**Torque Technology has upgraded all button type clutch packs to ceramic buttons.**

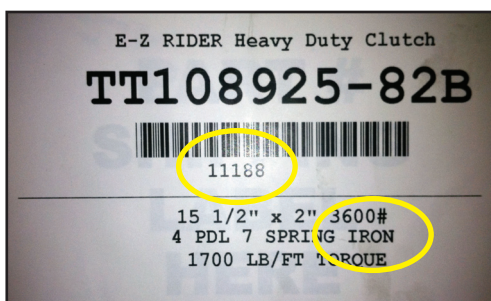
Over the past 10 years, truck and engine manufacturers have significantly increased horsepower and torque. The new ceramic button clutch disc performs better in these high torque applications.

- Torque Technology’s ceramic button provides roughly 10-15% more holding power (torque capacity) than carbotic (iron) buttons. This reduces the possibility of slipping.
- The new ceramic buttons have the same wear characteristics as iron buttons.
- Ceramic button clutch packs are the OEM standard.
- The new ceramic buttons are more eco-friendly because they are lead free.

Old Label

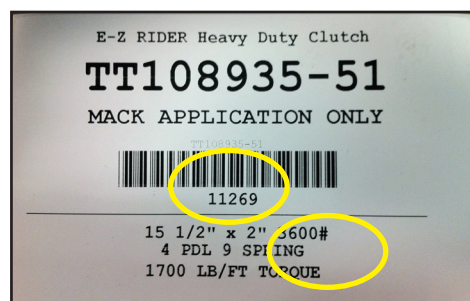
All production as of 9-25-2011 is ceramic and you can determine this two different ways on the label.

1. The Julian date is listed below the bar code, 11262 and higher is ceramic.
2. In the description, the previous packs with iron buttons had that noted on the label. The newer packs with ceramic buttons do not show “iron”.
